ARCHITECTURAL REVIEW BOARD MEETING

APRIL 25, 2023 IN THE CITY COUNCIL CONFERENCE ROOM AT 5:00 PM

PROJECT NUMBER: SP2023-013
PROJECT NAME: Site Plan for Alkaios Transportation
SITE ADDRESS/LOCATIONS: 1209 N GOLIAD ST

PROJECT NUMBER: SP2023-014
PROJECT NAME: Amended Site Plan for 108 St. Marys
SITE ADDRESS/LOCATIONS: 108 ST MARYS ST

SITE & LANDSCAPING PLAN
ALKAIOS TRANSPORTATION
1209 N. GOLIAD STREET ROCKWALL TEXAS 75087
CITY OF ROCKWALL
ROCKWALL COUNTY, TEXAS

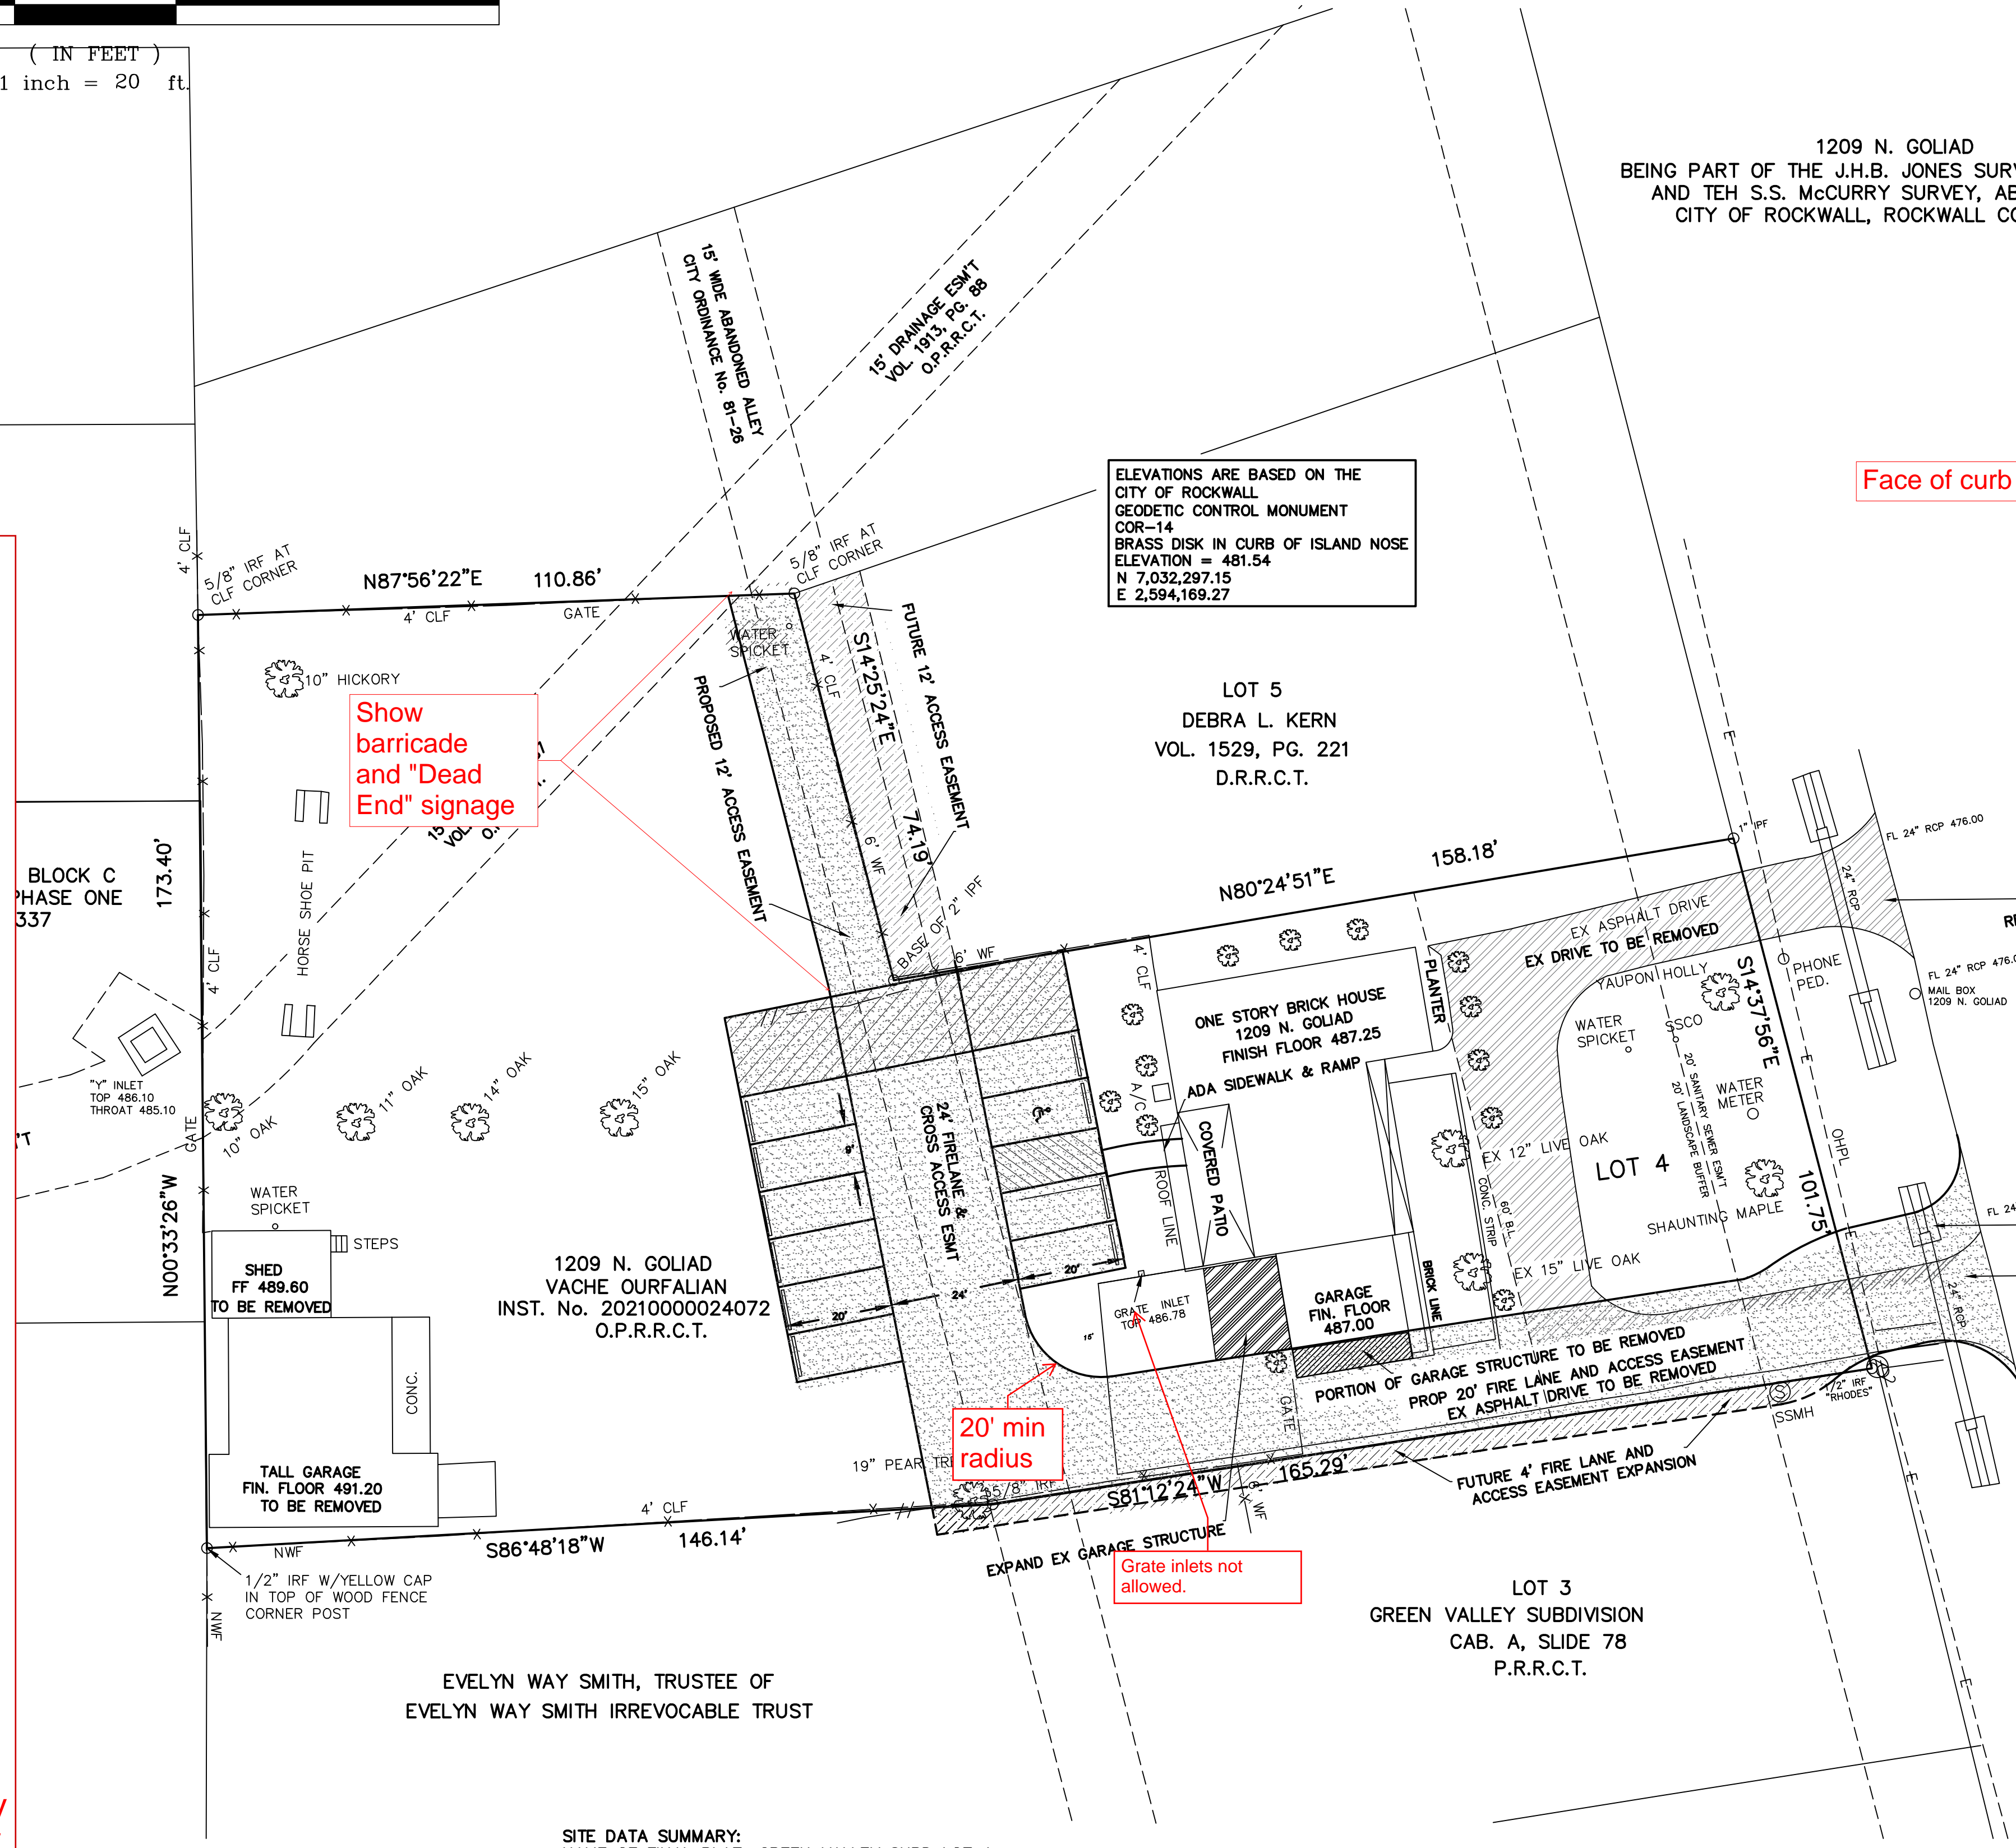
Face of curb

- Minimum easement width is 20'. No structures in easements.
- Must meet all of the City's Engineering Standards of Design and Construction.
- Need to show prop. and ex. utilities and approved flood plain

- TXDOT permitting required for work within Goliad ROW.
- Detention is required for new impervious area and future area of expansion as shown on landscape plan

Show barricade and "Dead End" signage

SITE & LANDSCAPING PLAN
ALKAIOS TRANSPORTATION
1209 N. GOLIAD STREET ROCKWALL, TEXAS 75087
CITY OF ROCKWALL,
ROCKWALL COUNTY, TEXAS

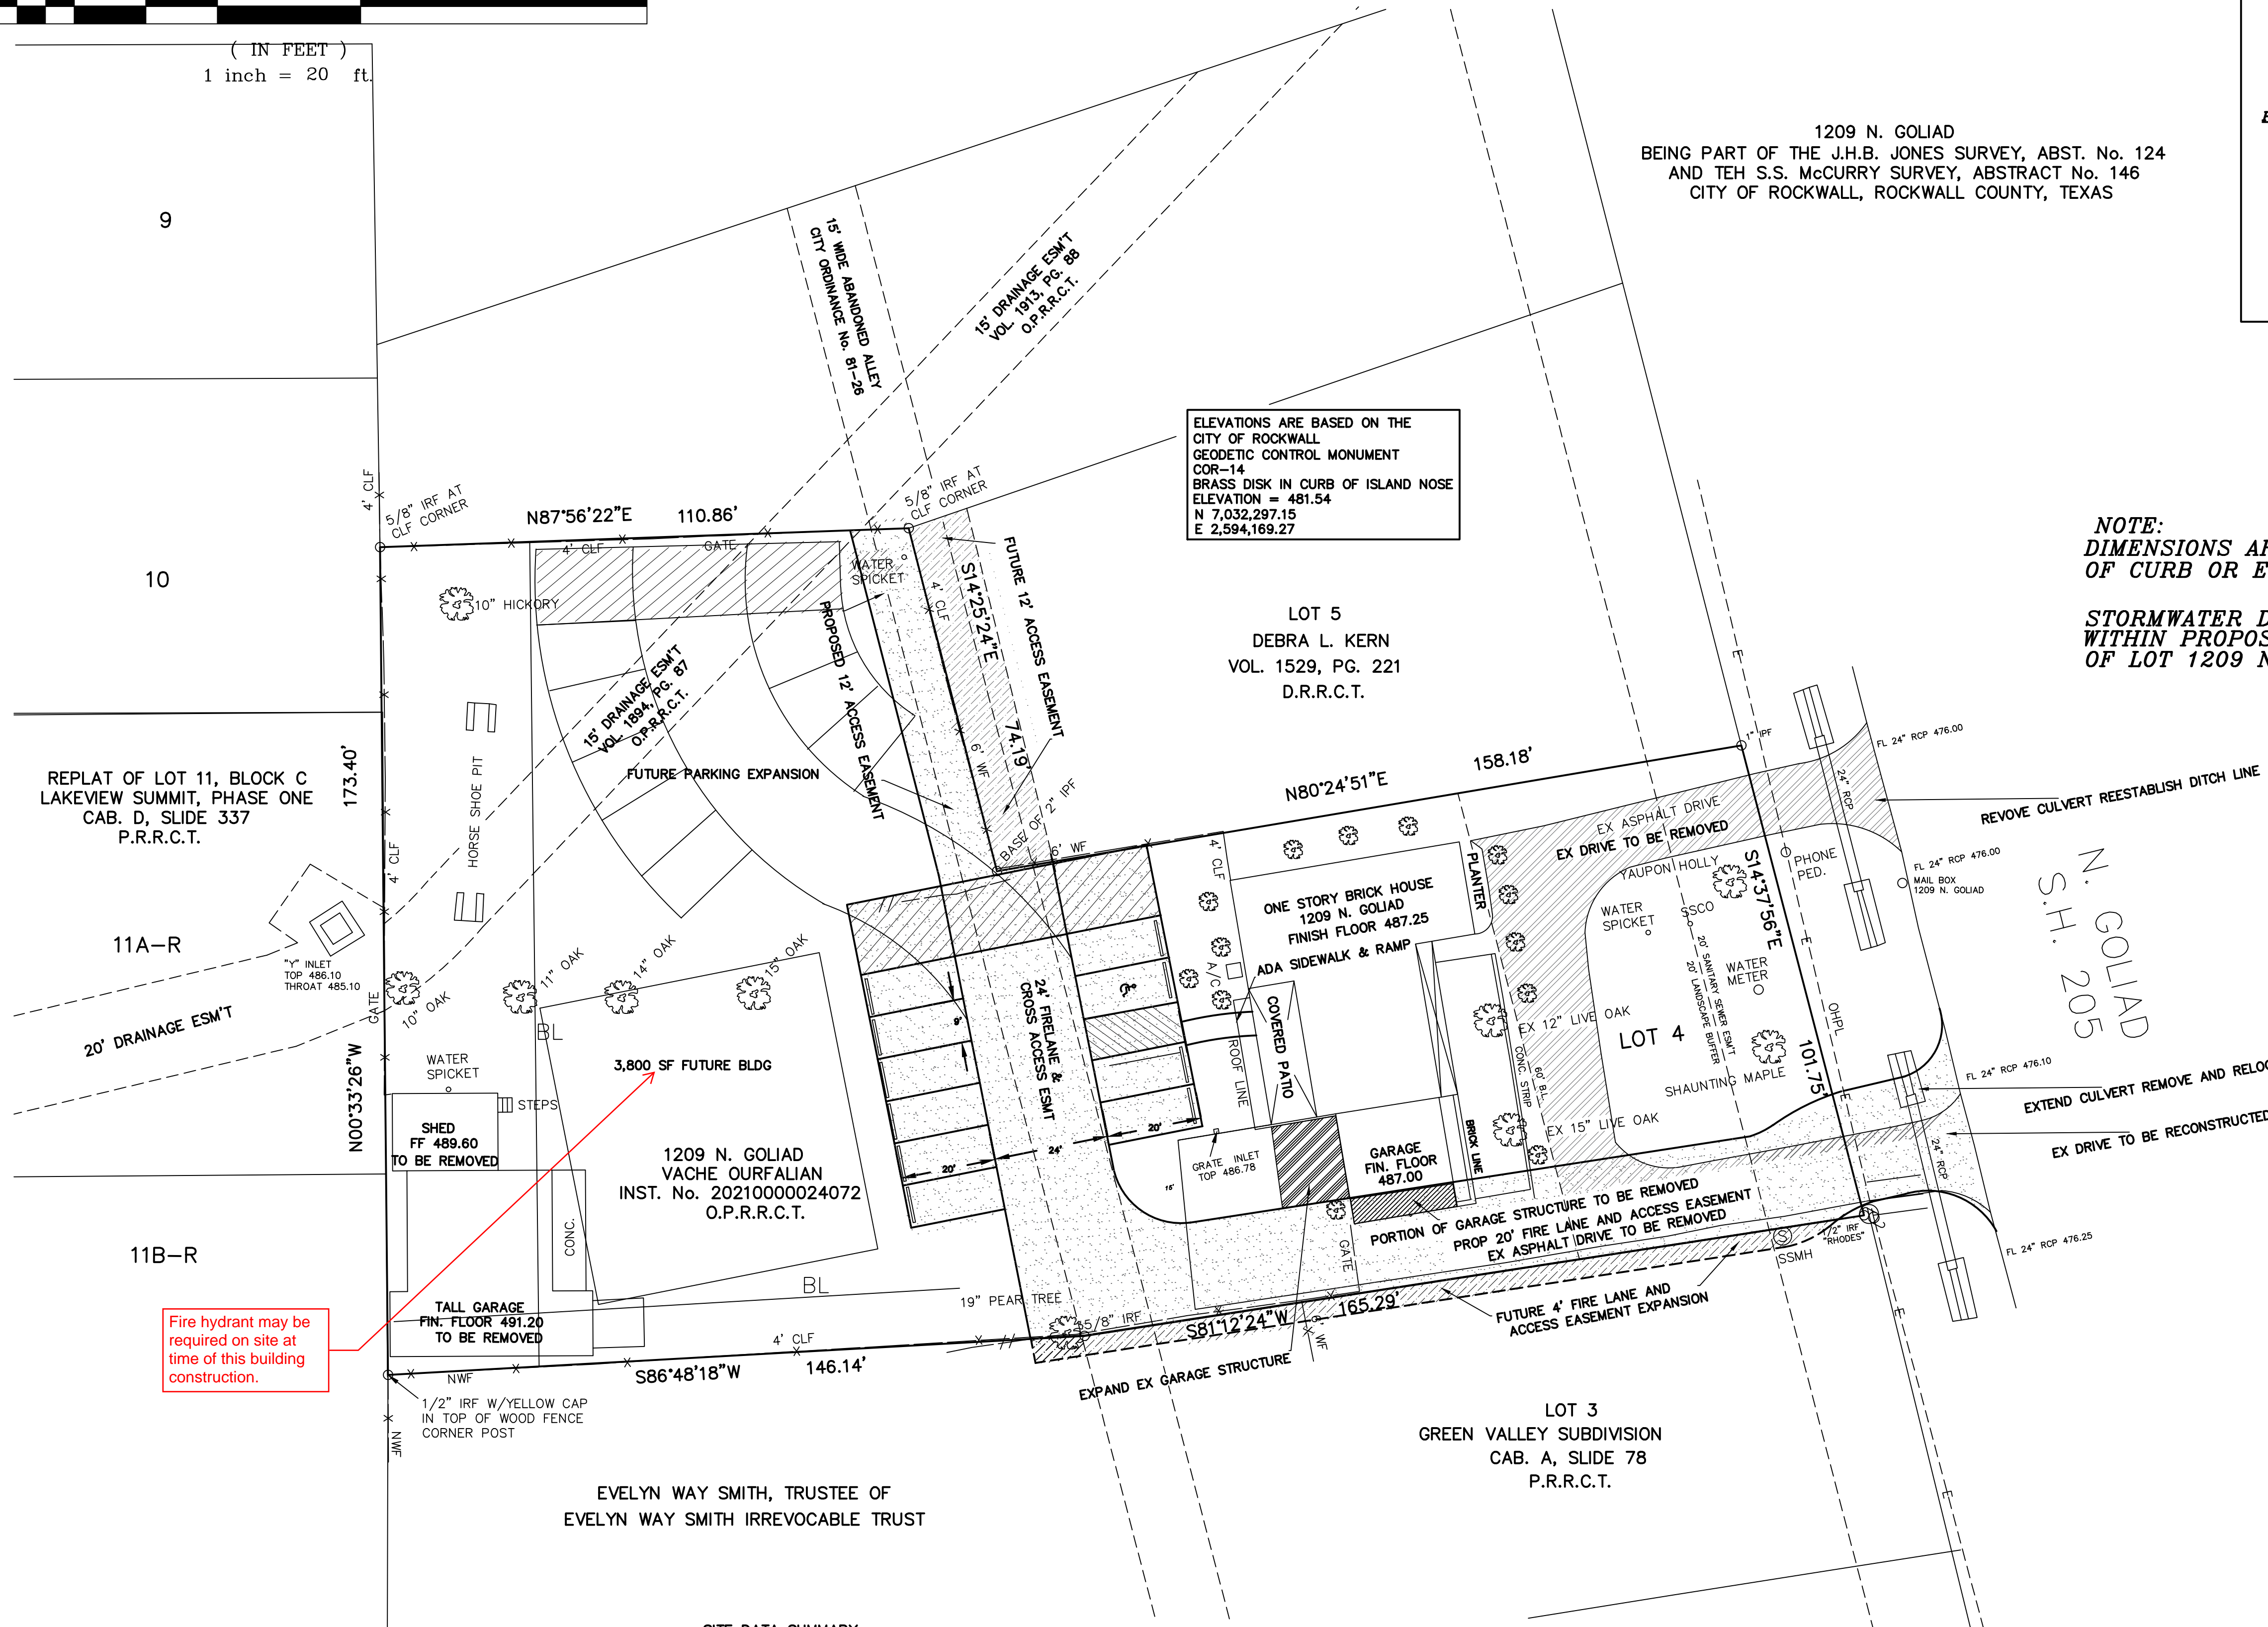
STORMWATER DETENTION TO BE CONTAINED
WITHIN PROPOSED PARKING IN REAR
OF LOT 1209 N. GOLIAD

Fire hydrant may be
required on site at
time of this building
construction.
